Donald C. Cook Nuclear Plant Units 1 and 2
ANNUAL ENVIRONMENTAL OPERATING REPORT

Annual Environmental Operating Report

January 1 through December 31, 2000

ATTACHMENT A
SGRP ENVIRONMENTAL REVIEWS

Haul Route Modification

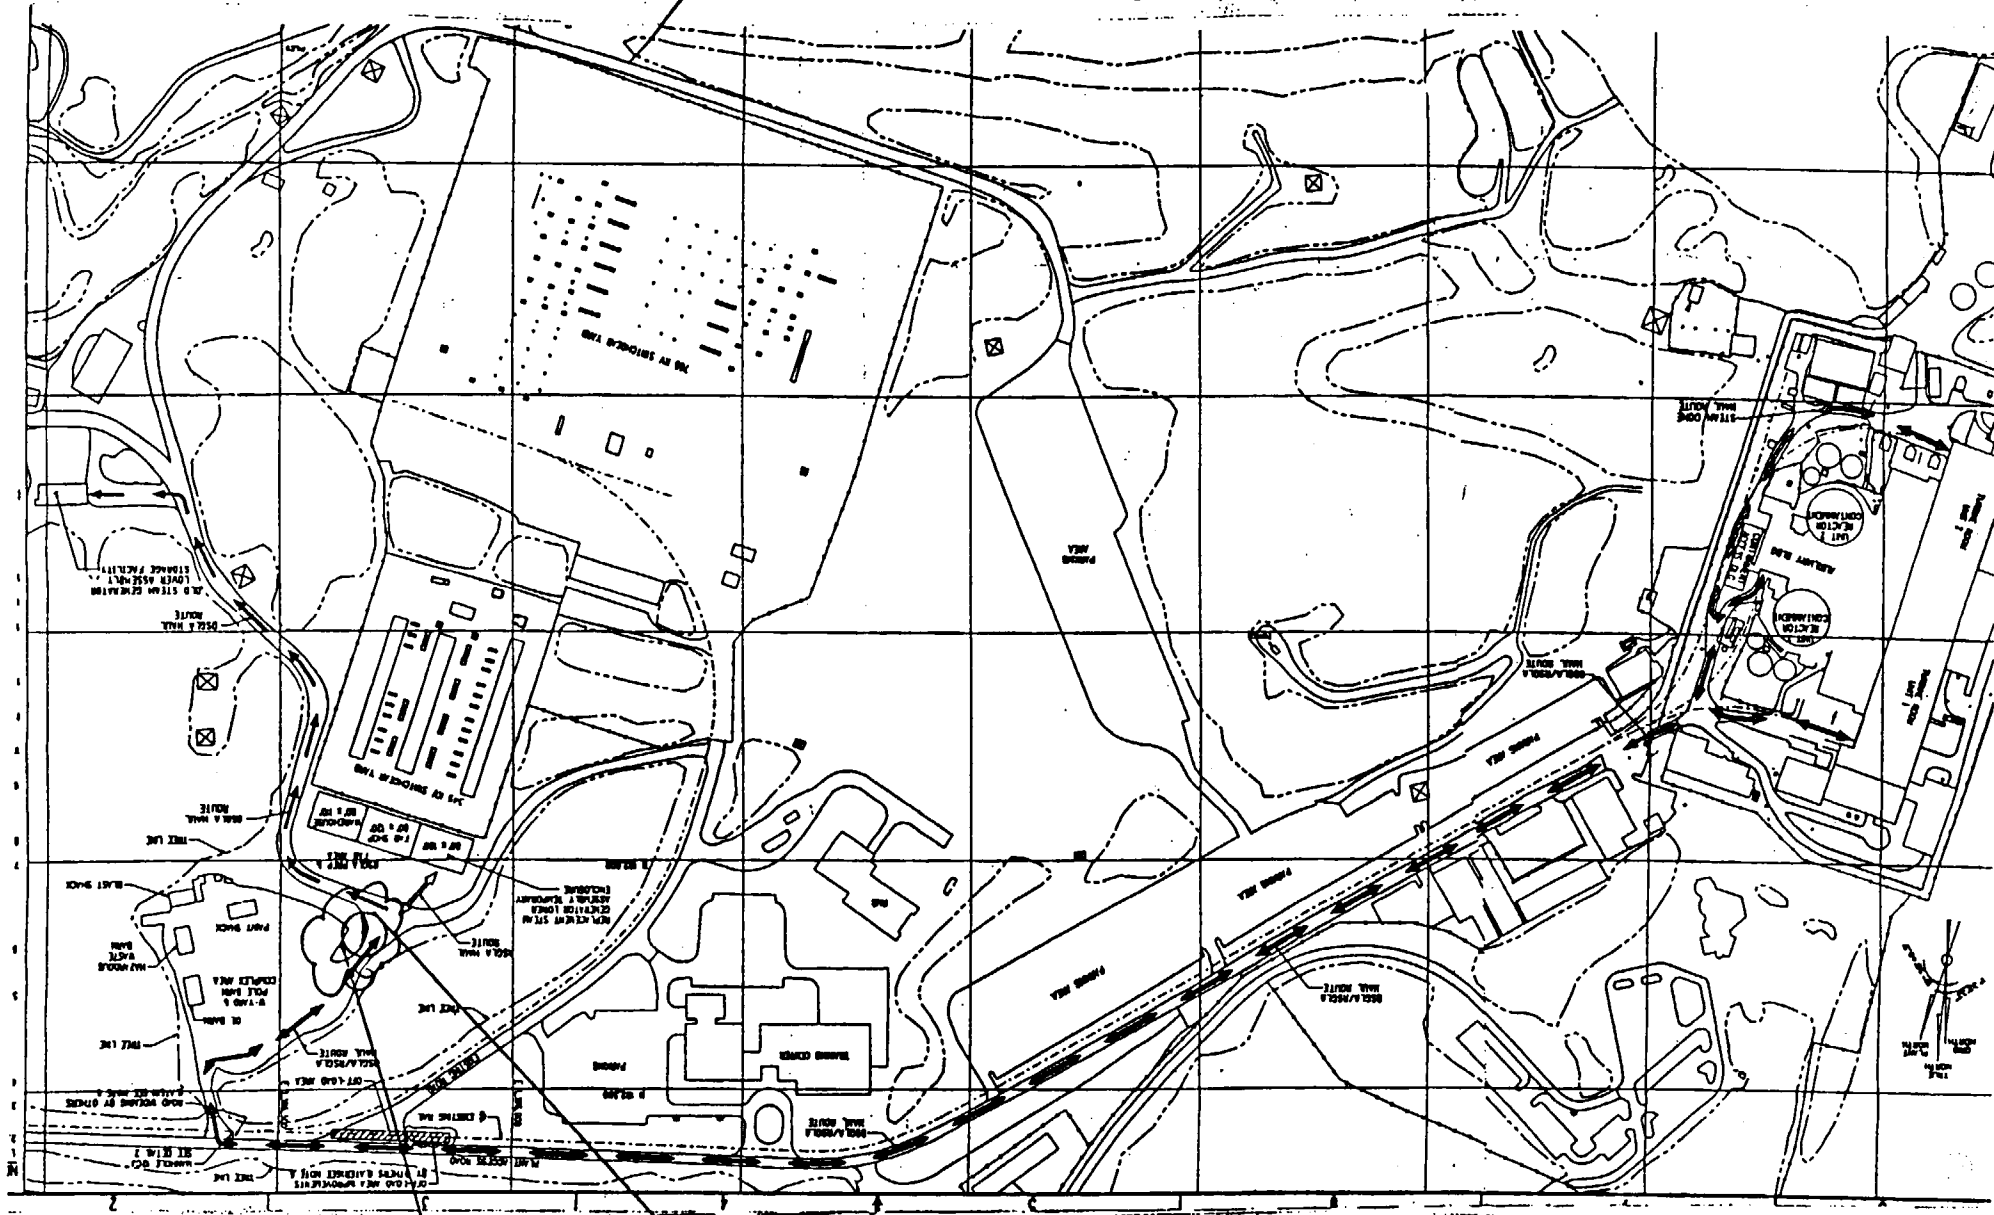
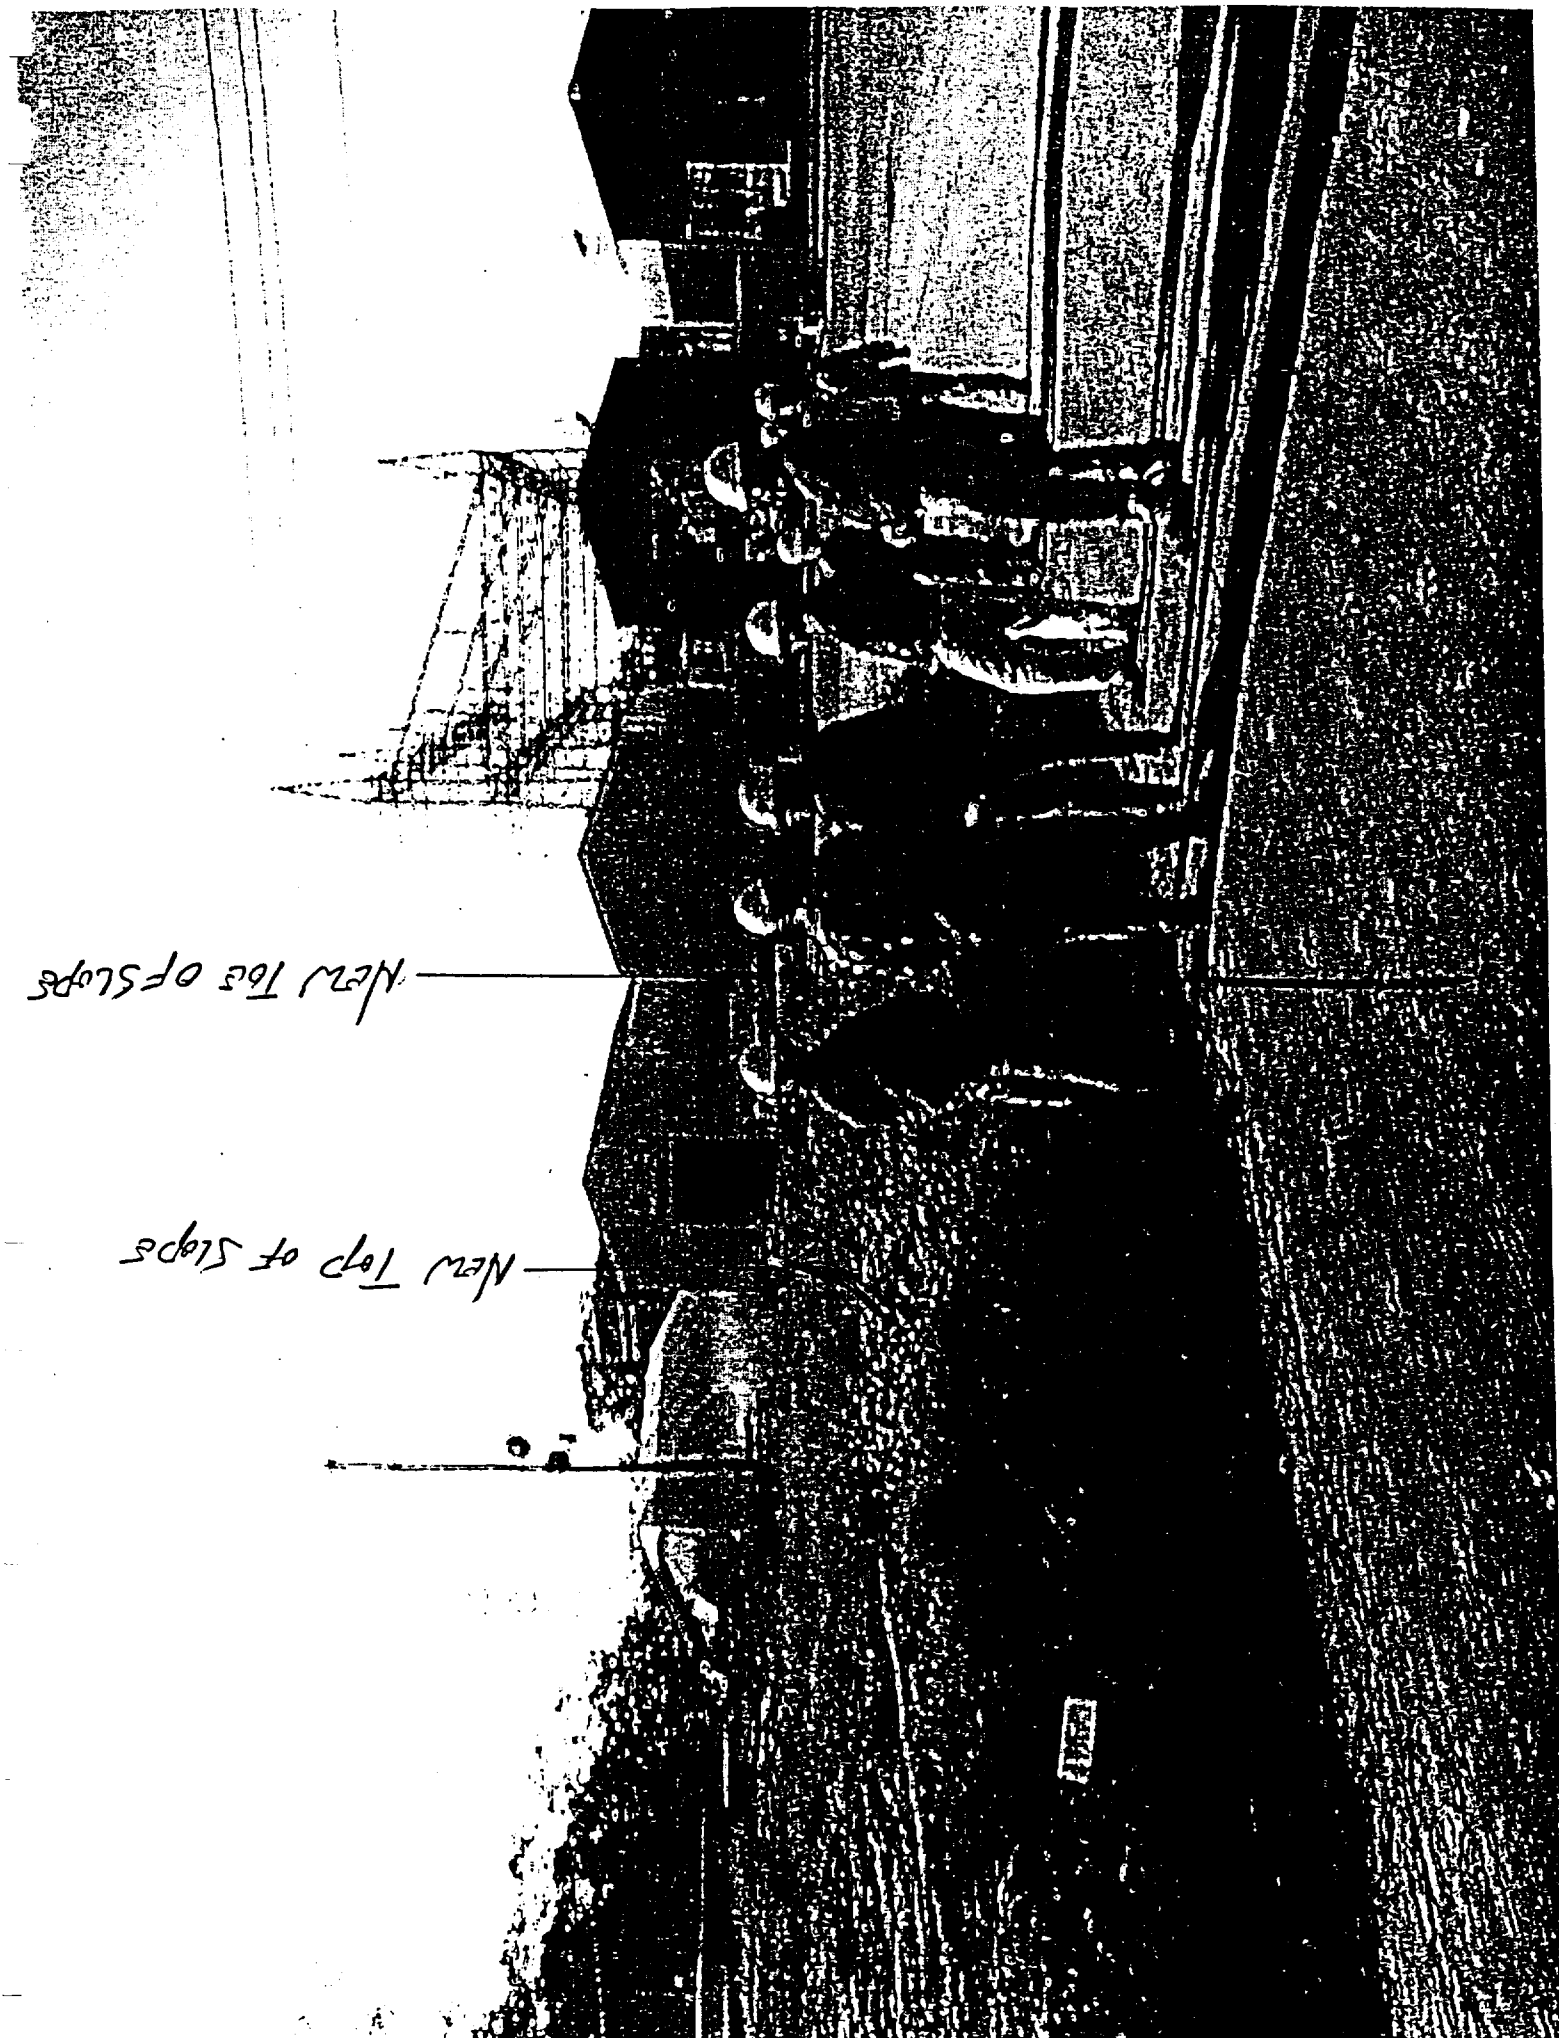
INCREASE ROAD WIDTH NORTH OF 345 KV YARD
AND SLOPE BANK BACK ON A 3/1 SLOPE.
- SEE ATTACHED HAND SKETCH -

Perform work as described in attached drawing

No additional permits required

ATTACHMENT TO ENV. PERMIT
FOR LDGP 310

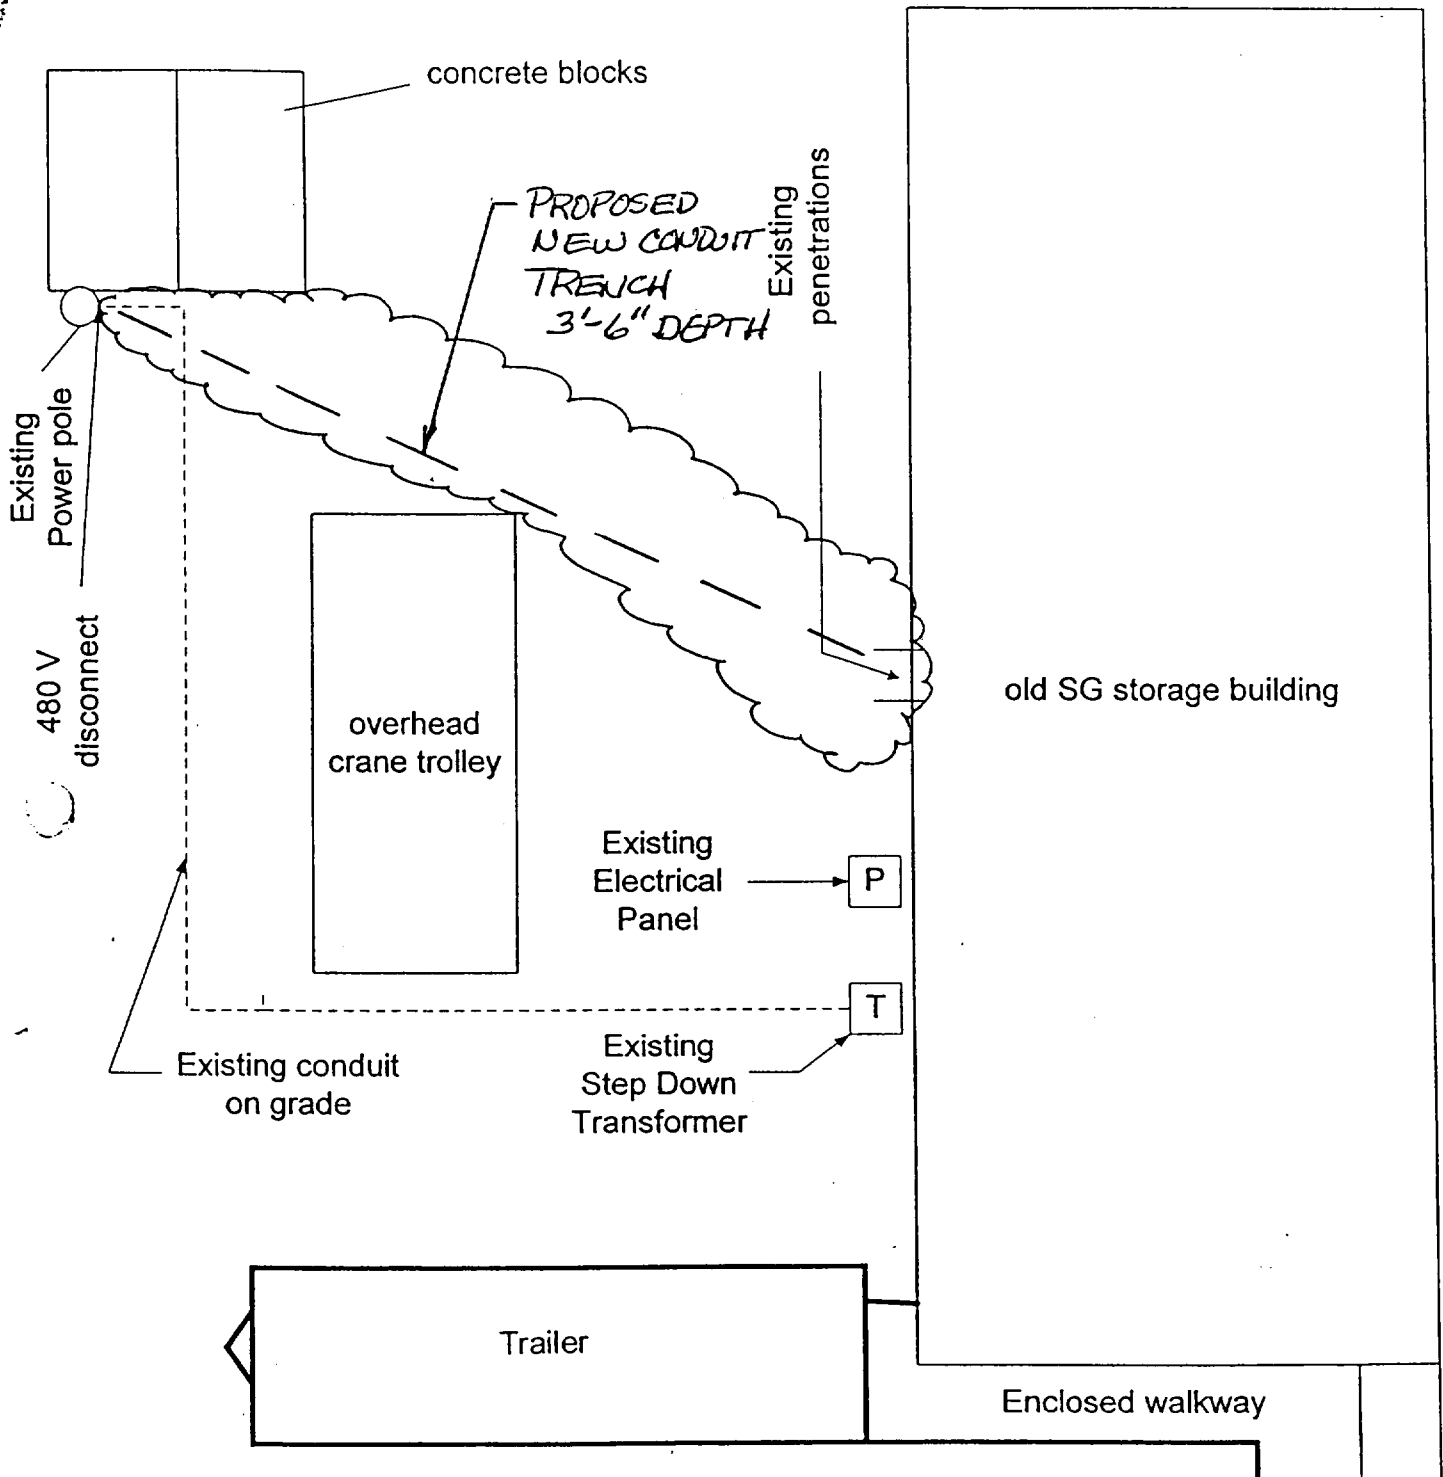
EXCAVATE TRENCH TO INSTALL PERMANENT ELECTRICAL FEED
TO THE STEAM GENERATOR MAUSOLEUM. SEE ATTACHED
SKETCH. TRENCH TO BE BACKFILLED USING SPOIL MATERIAL.

prevent soil erosion during trenching. Protect nearby Creek
from silting - should be prevented by vegetation established
down bank from the site and the creek.
